DESIGN FEATURES

## 5.0 DESIGN FEATURES

## DESIGN FEATURES

Figure 5.1-2

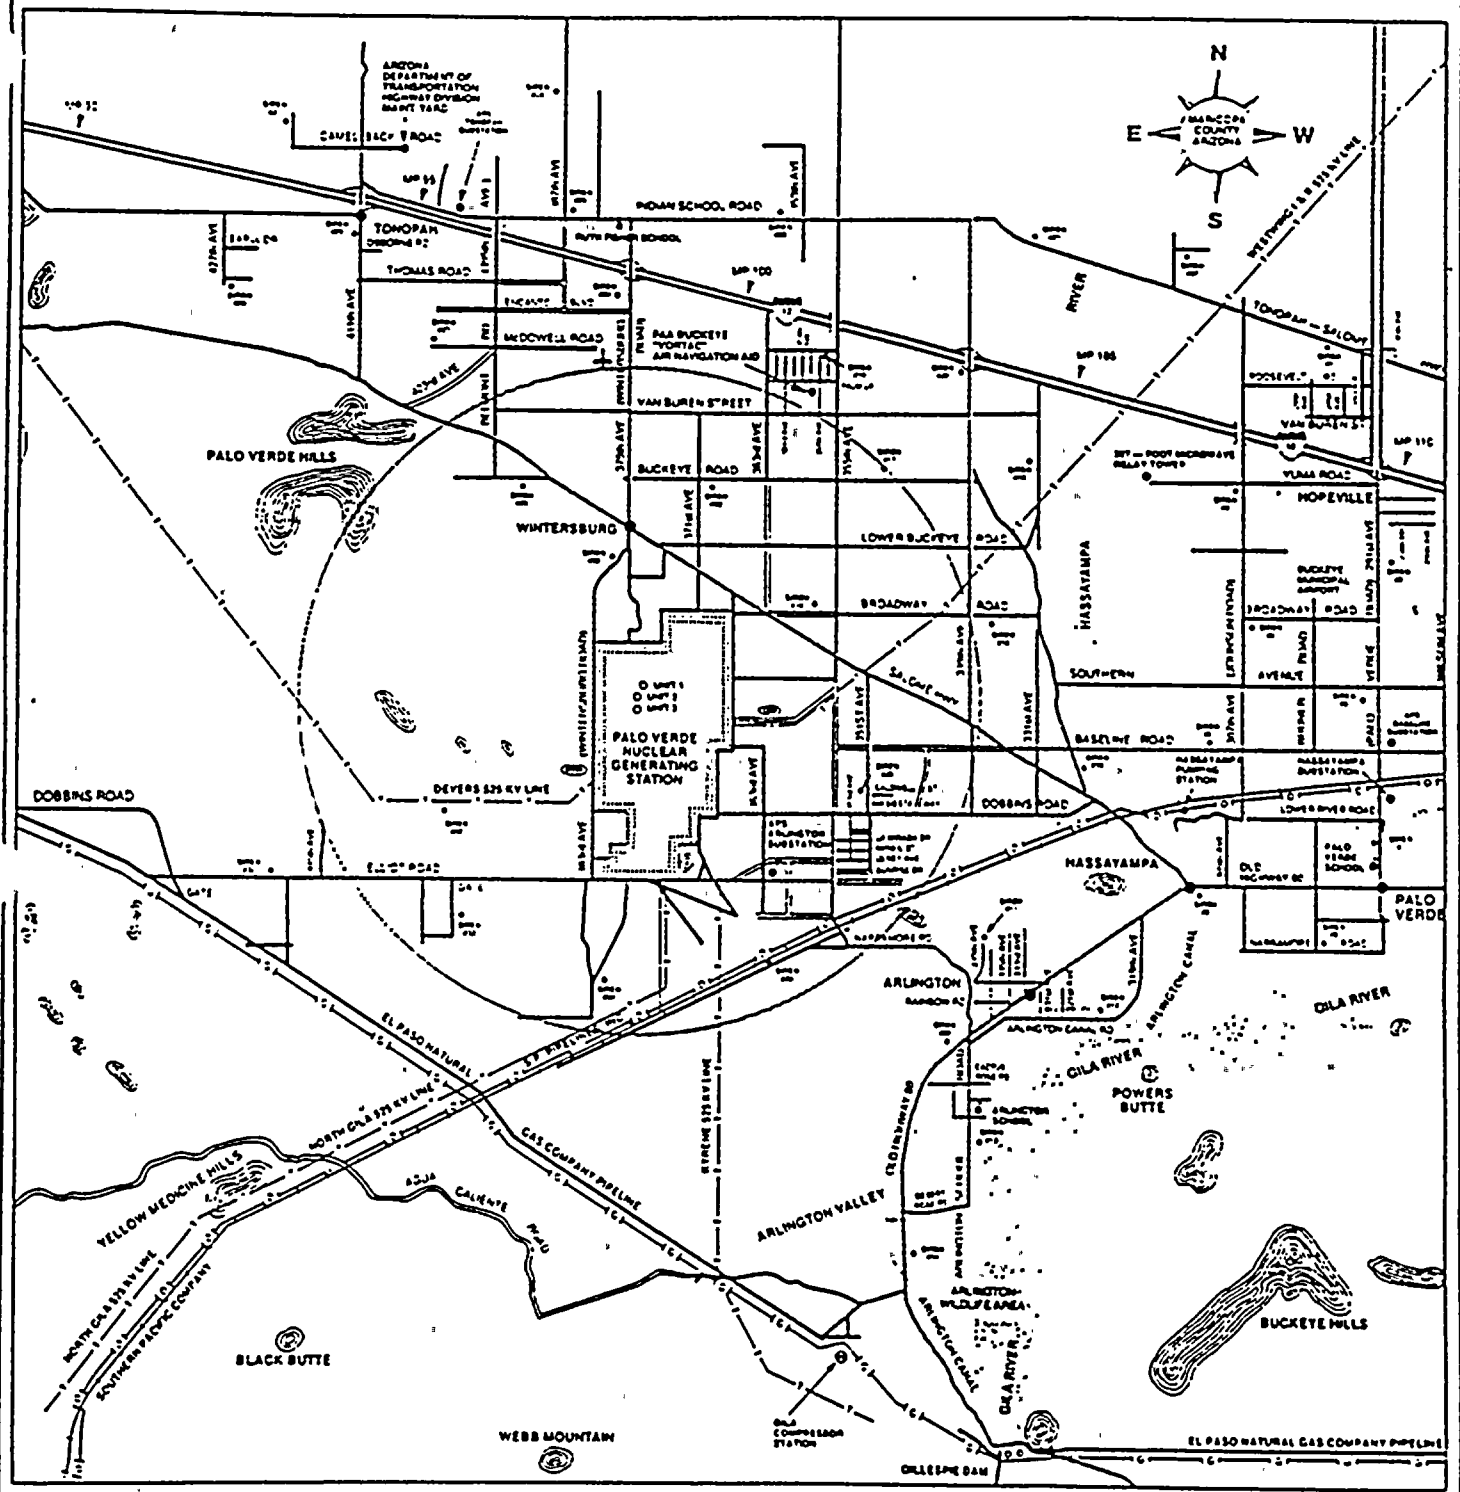
~~5.1.2 The low population zone shall be as shown in Figure 5.1-2.~~

DELETE

Figure 5.1-1  
Site and Exclusion Boundaries

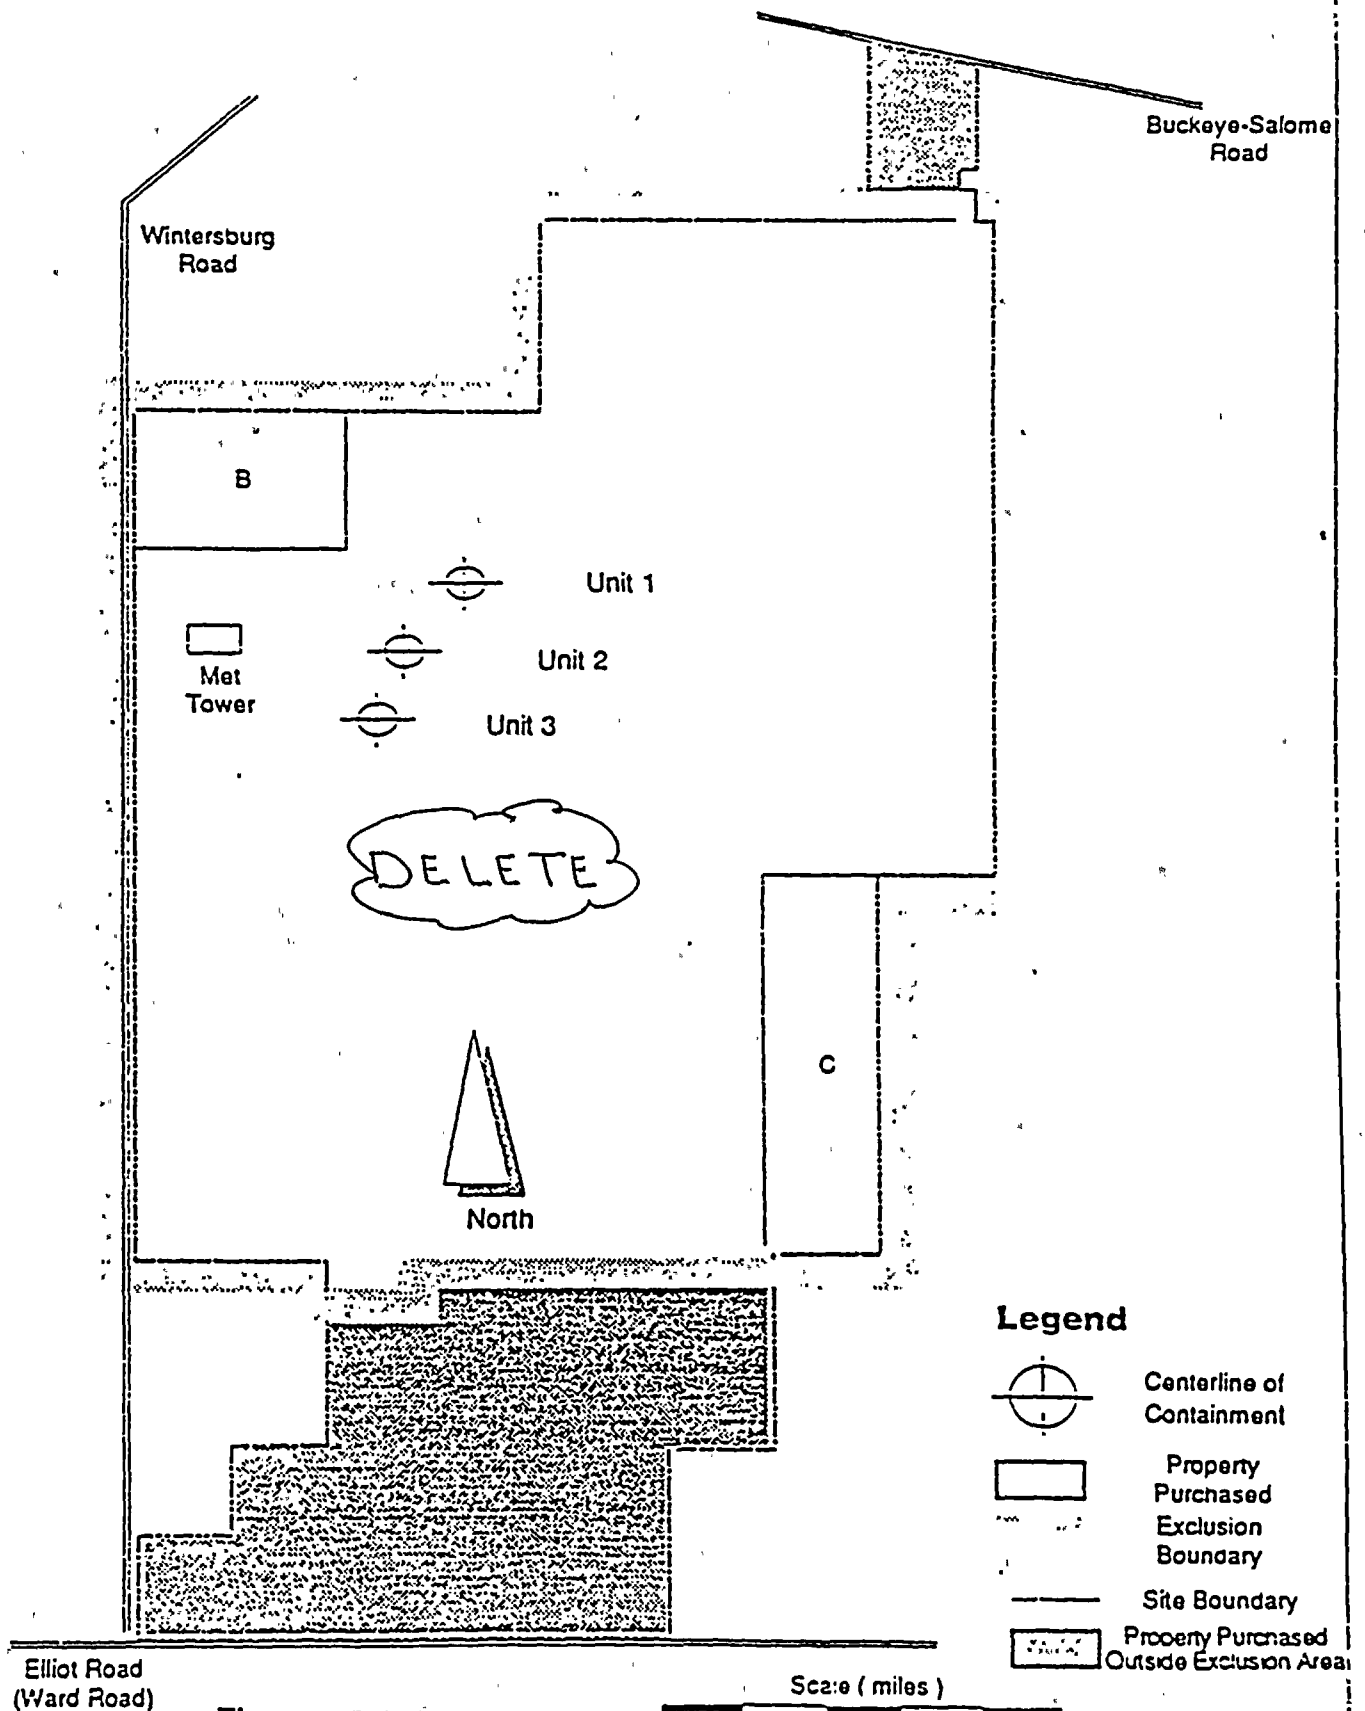
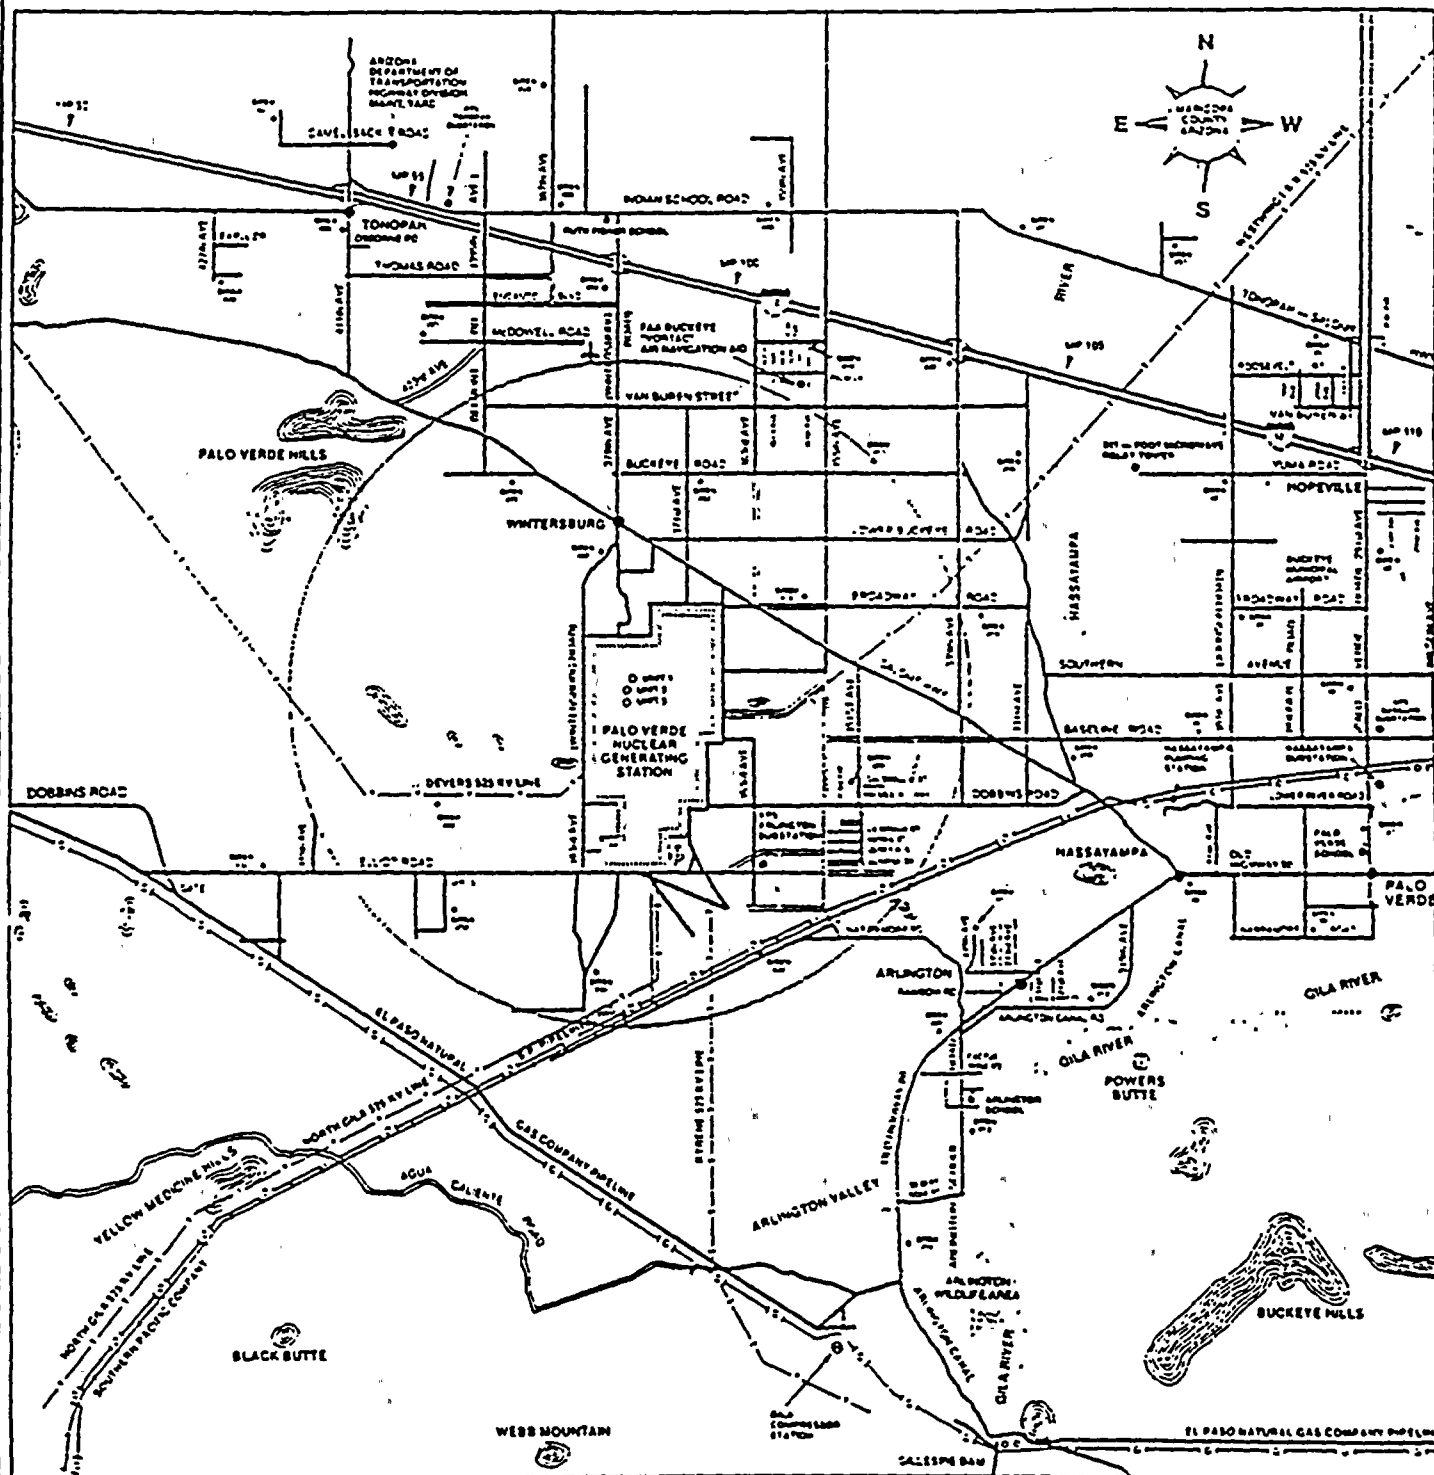
See new writeup

~~5.1.1 The site and exclusion boundaries shall be as shown in Figure 5.1-1.~~
